## Department of Transportation

#### MEMORANDUM

**SUBJECT:** BZA Case No. 20472 – The River School (4220 Nebraska Avenue NW)

**Figure 1**  
 Rerouted Left Turns Associated with "No Left Turn"  
 Restriction at Nebraska Avenue and Warren Street

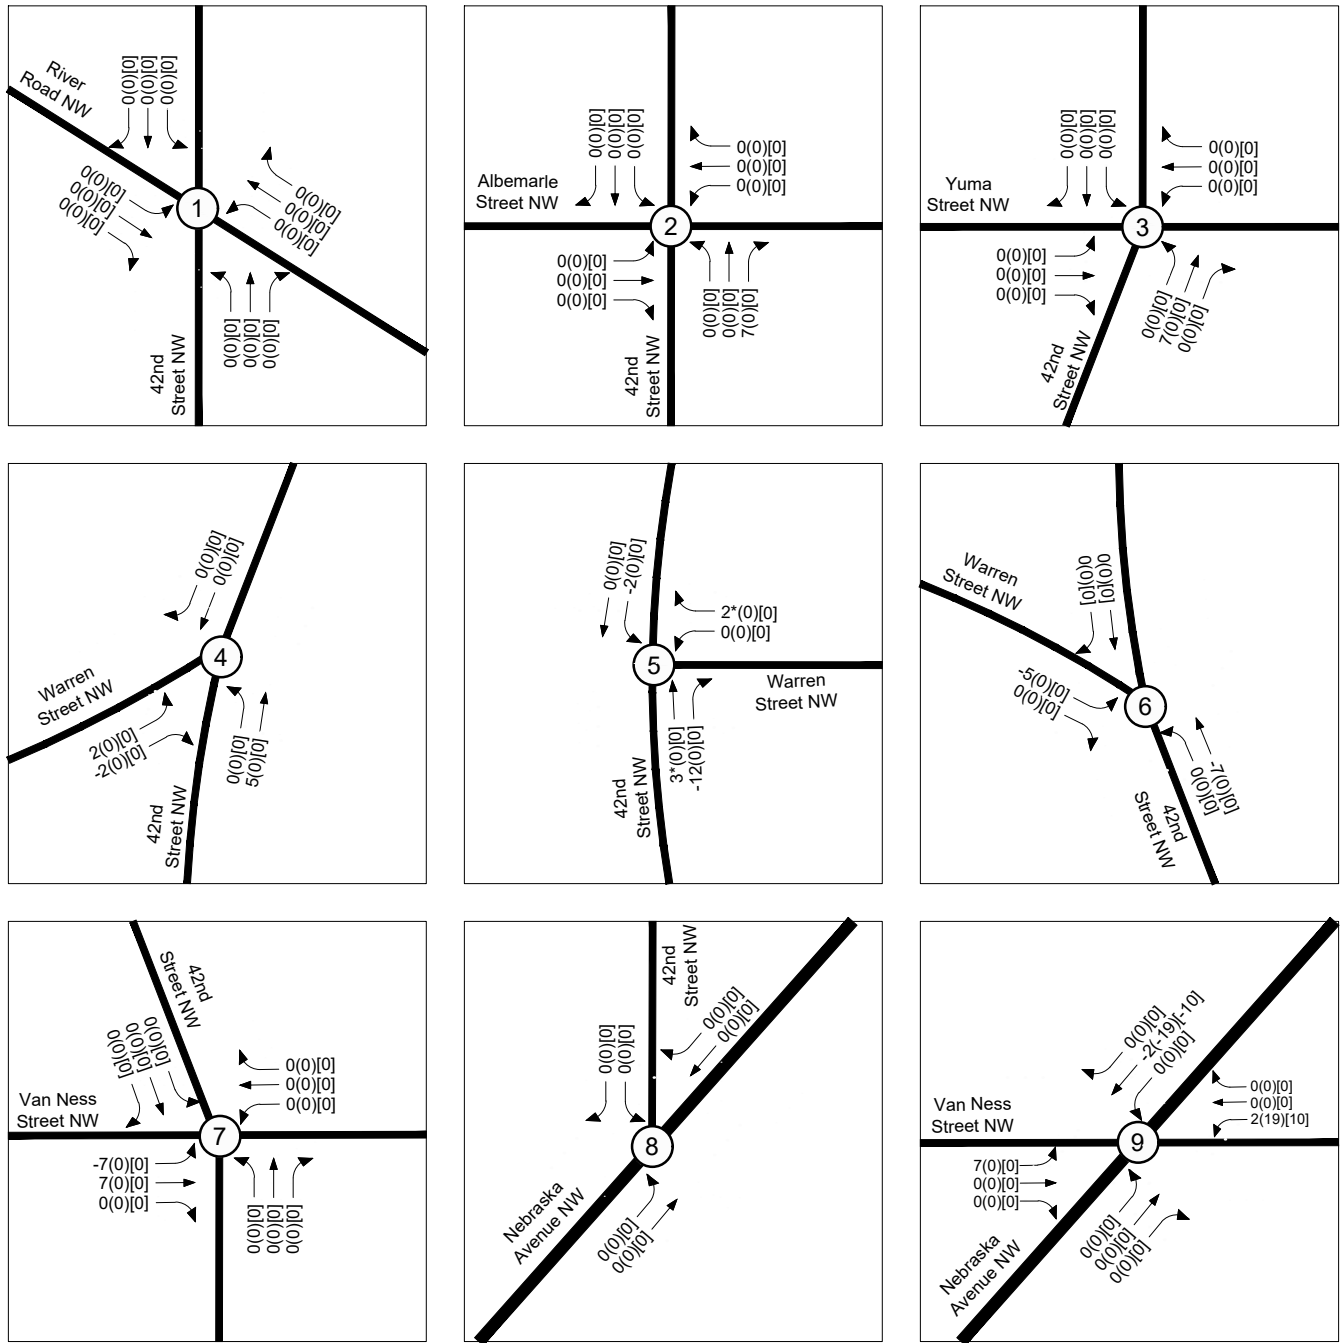
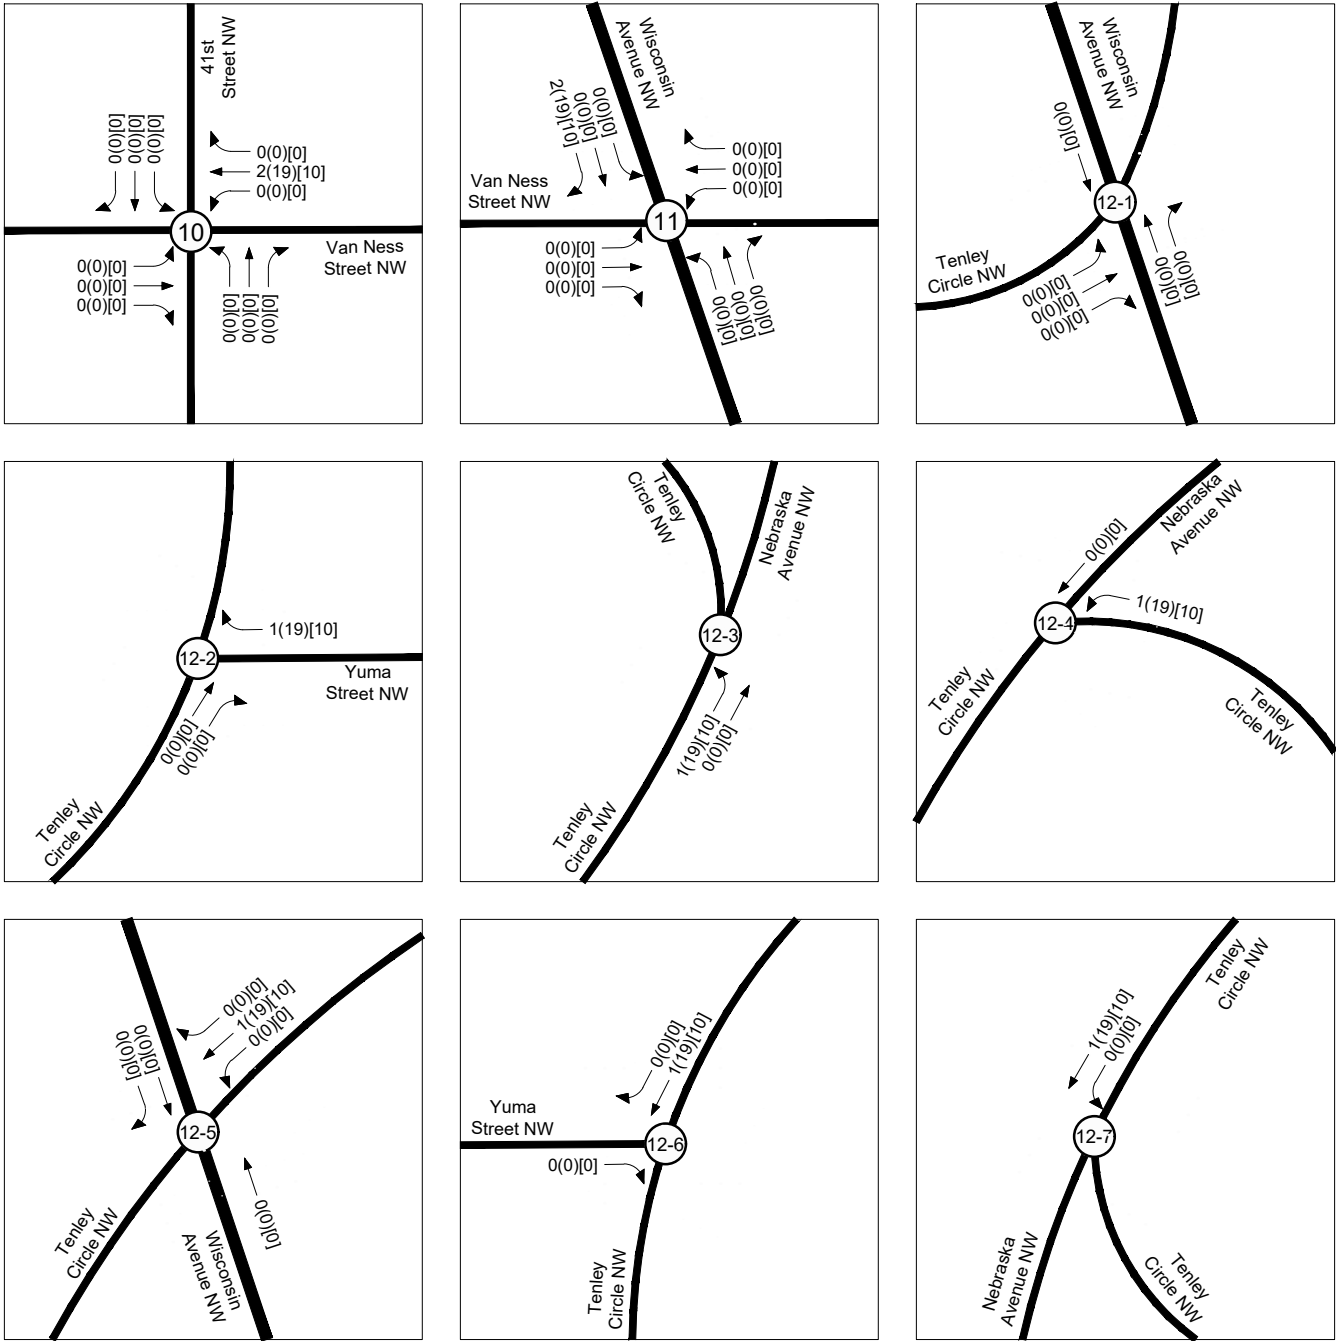
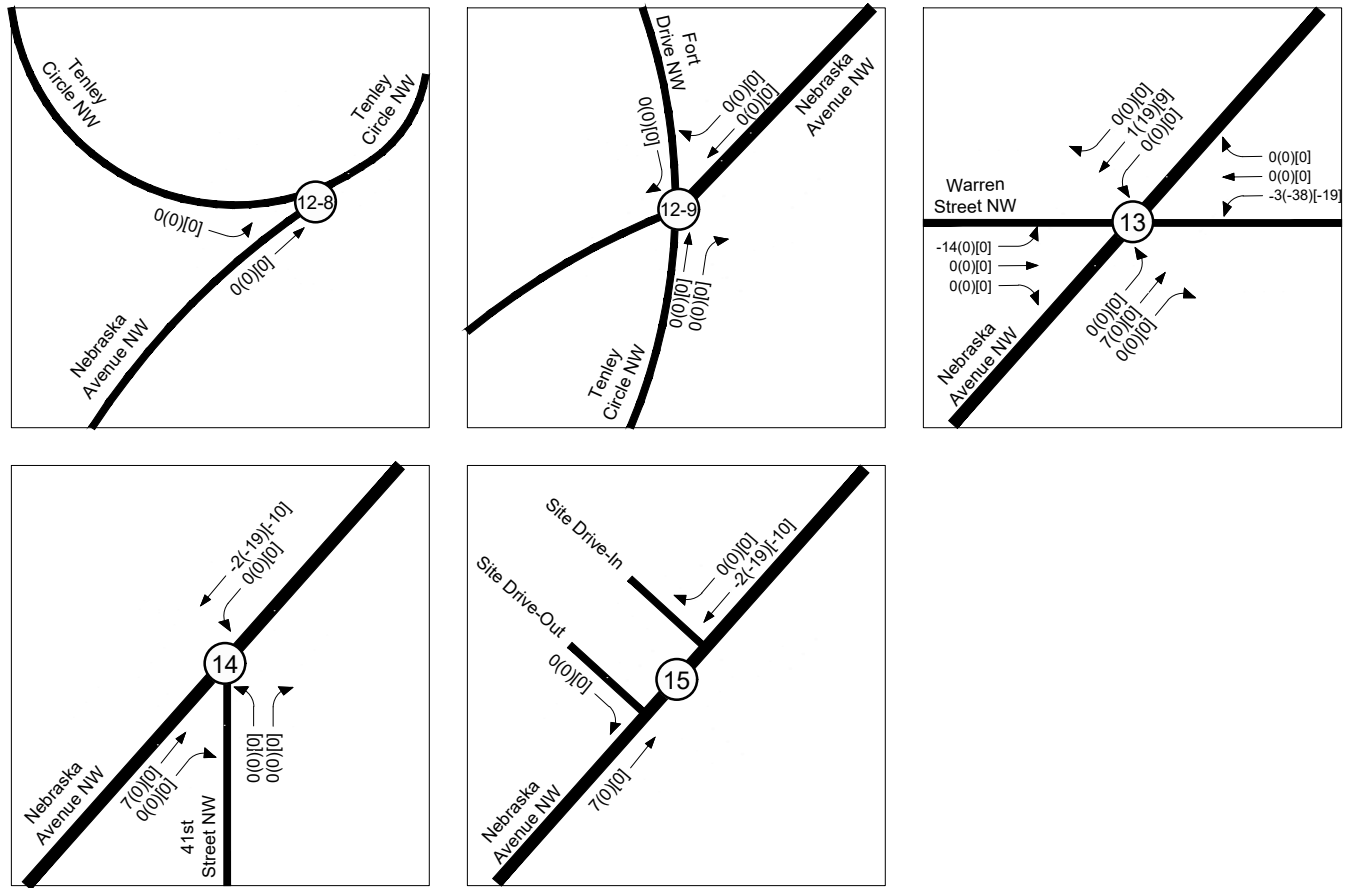
The CTR recommended left turn restrictions at the Nebraska Avenue/Warren Street intersection as a means to reduce delay and also reduce cut through traffic on Warren Street (a concern voiced by some members of the community). As requested, the rerouted left turn assignment is shown on Figure 1.
